### CITY OF ALBUQUERQUE

**RE:** Sterling Downtown - 800 Silver

**Conceptual Grading Plan**

Engineer's Stamp Date 7-6-16 (File:K13D013)

CONCEPTUAL GRADING PLAN

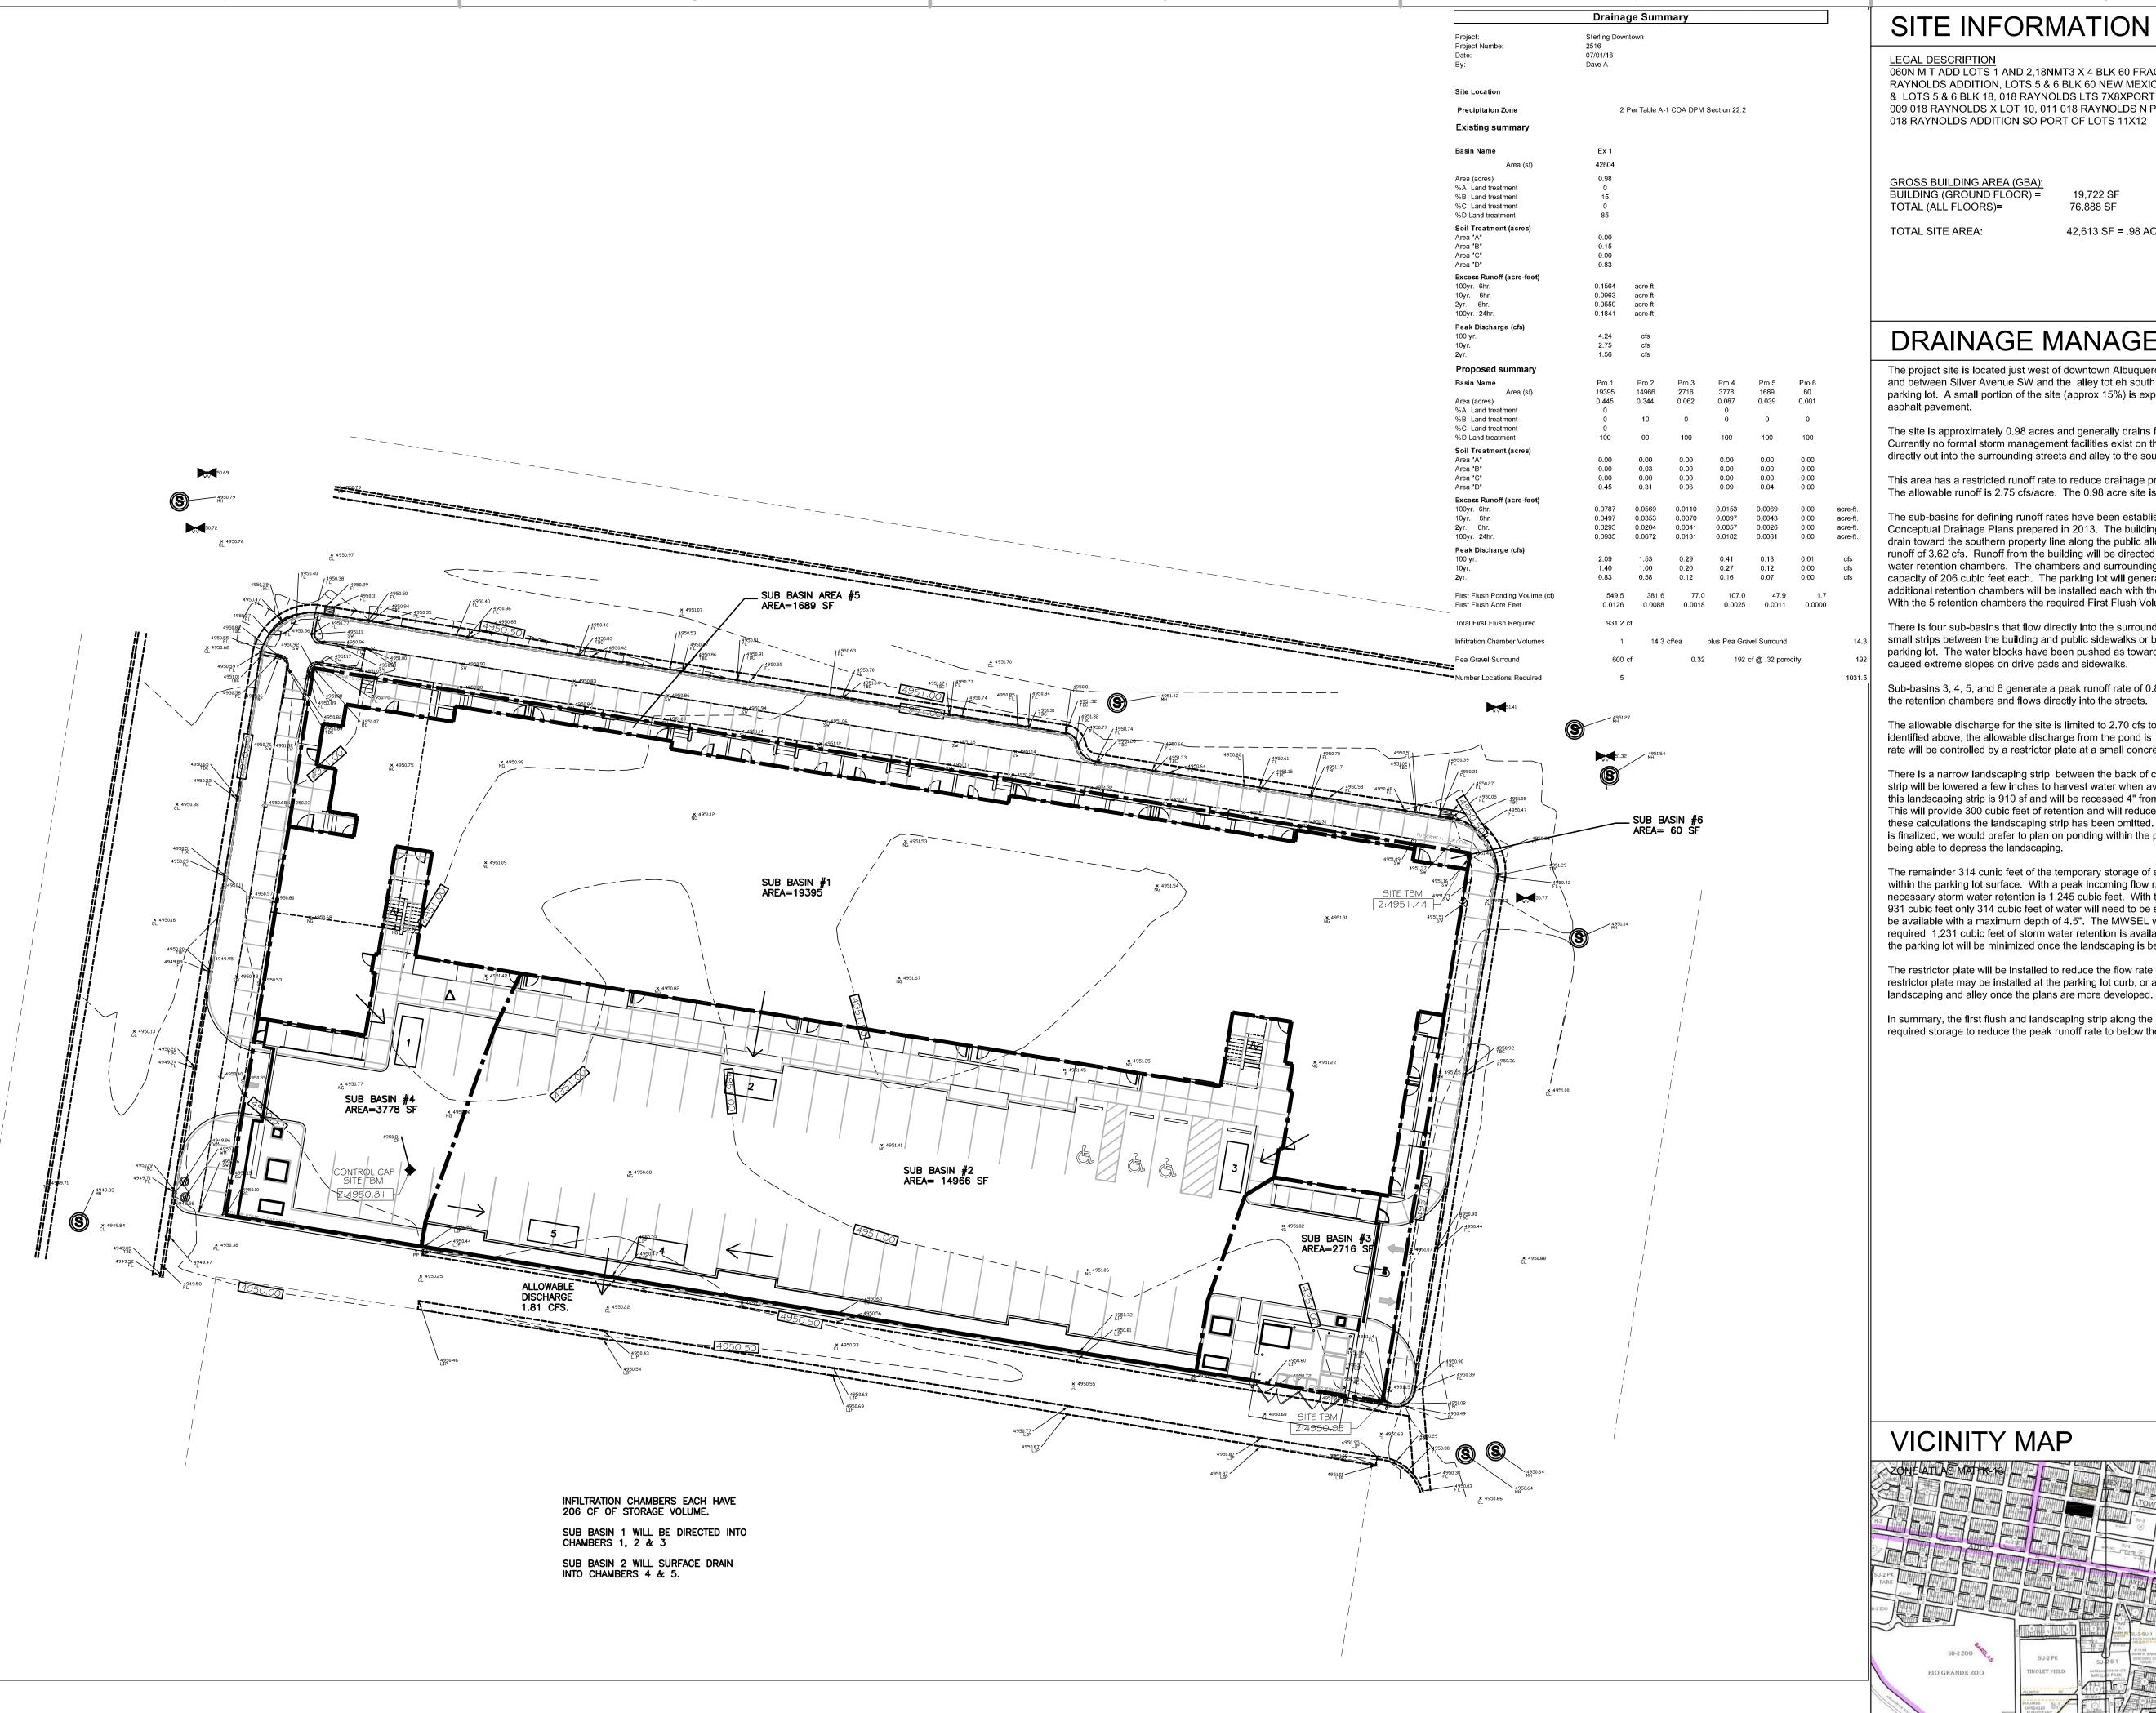
Per our phone conversation it is understood that much of the existing curb, gutter and sidewalk is intended to remain undisturbed, except to close unneeded driveways. Please clarify the site plan the intent. The submittal showed dark line work suggesting that the curb and gutter would be reconstructed.

Also per our phone conversation, the Building Permit submittal will be expected to include a depressed landscape buffer between the sidewalk and the back of curb, as well as curb cuts along Silver Ave into the buffer to provide an outfall for nuisance ponding along the street.
